Planning Application LPA Ref: PL/2021/09778 Land at Station Works, Station Road, Tisbury, Wiltshire SP3 6QU

Appeal Reference: APP/Y3940/W/22/3308919

Statement of Case Appendix A – Access Scheme

Prepared for Tisbury Parish Council

12. Appendix C – Carriageway Widths

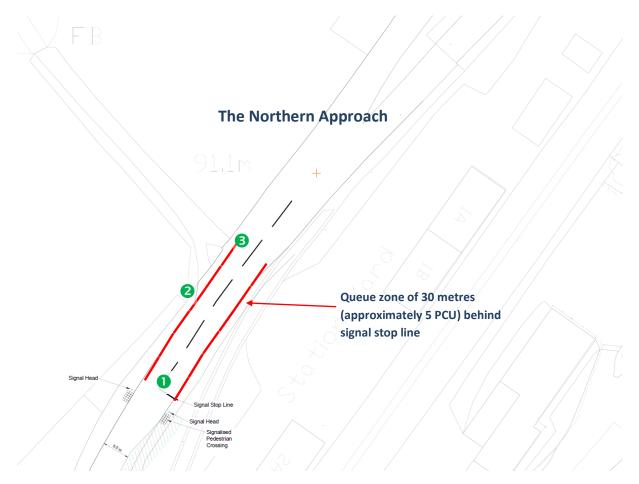
- A 5.17. In 2021, representations from members of the public questioned the carriageway width in this zone along the Northern approach to the bridge, which reduces to approximately 6 metres in places.

- A 5.18. Pictures of this section of road are provided at Appendix C.
- A 5.19. In their submission, Dorset and Wiltshire Fire and Rescue Service provided a plan showing the chief area of concern. It comments that the road along much of this stretch can only support a single vehicle, that there is no provision for a pavement and that as a result of the carriageway configuration they would not be able to proceed with caution at a red light. Their comments and the plan, as it appears in the applicant's Statement of Community Involvement²⁴, are also reproduced in Appendix C.

Comments by Dorset and Wiltshire Fire and Rescue Service

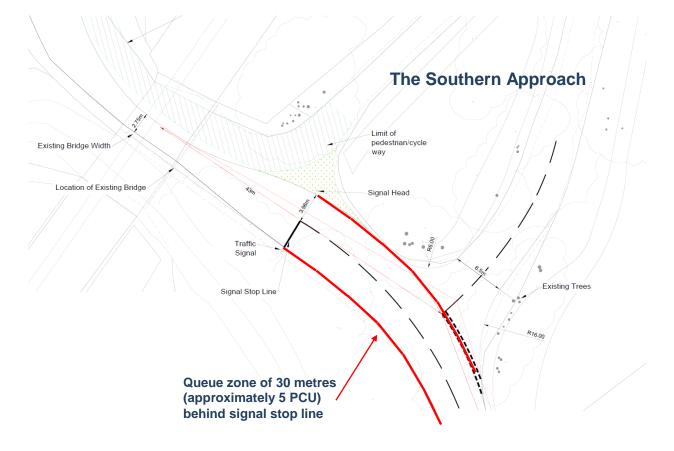
The following comments on the Northern approach appear in the Statement of Community Engagement⁴⁷:

Google maps image of road as it stands the red line is highlighting that is currently wide enough for one car at time. Unsure if any plans to widen or add a pavement as there is no pavement currently. So adding traffic lights could delay us if there is a que. From the traffic lights we would not be able to proceed with caution on a red light as the red may not be wide enough due to pavements each side

Location Plan

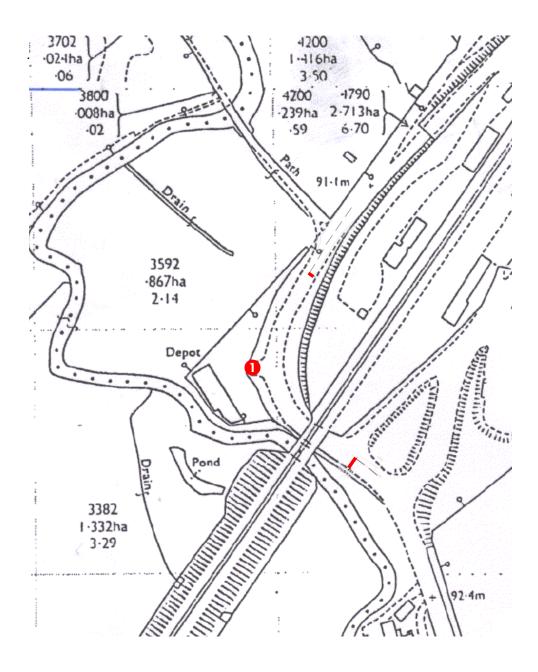
The location of the entrance/exit to the vehicle repair business at the Old Council Yard adjacent to the Three Arch Bridge is marked '1' in the plan below. The business lies within the proposed zone of controlled introduced under the access scheme, but is not subject to or protected by it.
